MODIFICATION EVD Valves to MFV Valves

**Kit number
ALT-KIT80284**

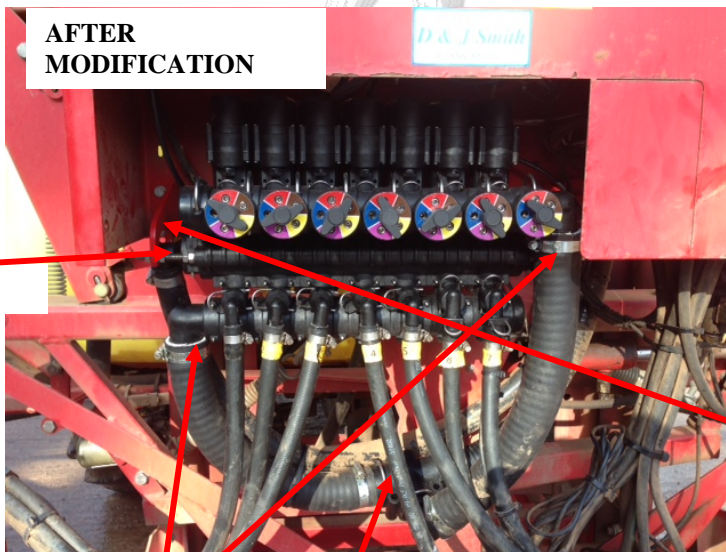
AFTER MODIFICATION

FEED TO VALVES

RETURNS – TEE PIECE FITTED TO RETURN LINE

**NEW MOUNTING BRACKETS
SOURCE FROM KVERNELAND**

**KV CODES VNB4095494
 VNB4095394**

FITTINGS INCLUDED IN KIT

- 1 X ALT80331 TEE
- 5 X ALT05241 AS40 CLIPS
- 2 X ALT06247 AS40 39MM ST
- 1 X ALT08275 AS40 39MM90
- 9 X ALT80349 AS24 15MM 90
- 7 x ALT18545 AS24 CLIP
- 2 X ALT47993 AS40 FEM CAP

Notes: Some additional fittings may be required depending on model.
